UNITED STATES PATENT AND TRADEMARK OFFICE

APPLICATION NO.	FILING DATE	FIRST NAMED INVENTOR	ATTORNEY DOCKET NO.	CONFIRMATION NO.
10/501,099	11/30/2004	Donald H. Warner	TRM TR010040	5611
33047 7590 04/02/2008 GROSSMAN, TUCKER, PERREAULT & PFLEGER, PLLC 55 SOUTH COMMERICAL STREET MANCHESTER, NH 03101				
EXAMINER				
FONSECA, JESSIE T				
ART UNIT		PAPER NUMBER		
3633				
MAIL DATE		DELIVERY MODE		
04/02/2008		PAPER

Office Action Summary

DETAILED ACTION

Fig. 4: Gill (US 5,896,717)

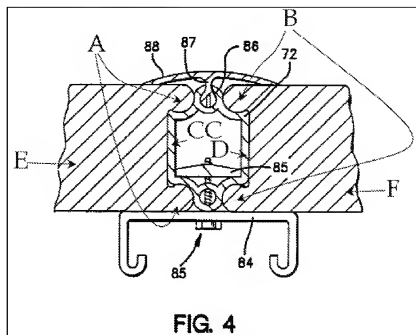
With regards to claim 1: Gill discloses a joint (fig. 4) capable of use with a trim panel comprising:

a first outer cover (E) having an inner surface, an outer surface and a connector portion (A) formed therein (fig. 4);

a second outer cover (F) having an inner surface, an outer surface and a connector portion (B) formed therein (fig. 4);

a connector platform having a first connector portion (CC) and a second connector portion (D), the first connector portion (CC) connected to the first outer cover connector portion (A) and the second connector portion (D) connected to the second outer cover connector portion (F) (fig. 4).

With regards to claim 2: Gill further discloses a joint cover (88) overlying the connector platform, the joint cover (88) covering the connection between the connector platform first connector portion (CC) and the first outer cover connector portion (A) and the joint cover (88) covering the connection between the connector platform second connector portion (D) and the second outer cover connector portion (B) (fig. 4).

With regards to claim 13: Gill discloses a method of forming joint (fig. 4) for a panel comprising:

providing a first outer cover (E) having an inner surface, an outer surface and a connector portion (A) formed therein (fig. 4);

providing a second outer cover (F) having an inner surface, an outer surface and a connector portion (B) formed therein (fig. 4);

connecting the first connector portion (CC) to the first outer cover connector portion (A) and connecting the second connector portion (D) to the second outer cover connector portion (F) (fig. 4)

With regards to claim 14: Gill further discloses providing a joint cover (88) overlying the connector platform, the joint cover (88) covers the connection between the connector platform first connector portion (CC) and the first outer cover connector portion (A) and the joint cover (88) covers the connection between the connector platform second connector portion (D) and the second outer cover connector portion (B) (fig. 4).
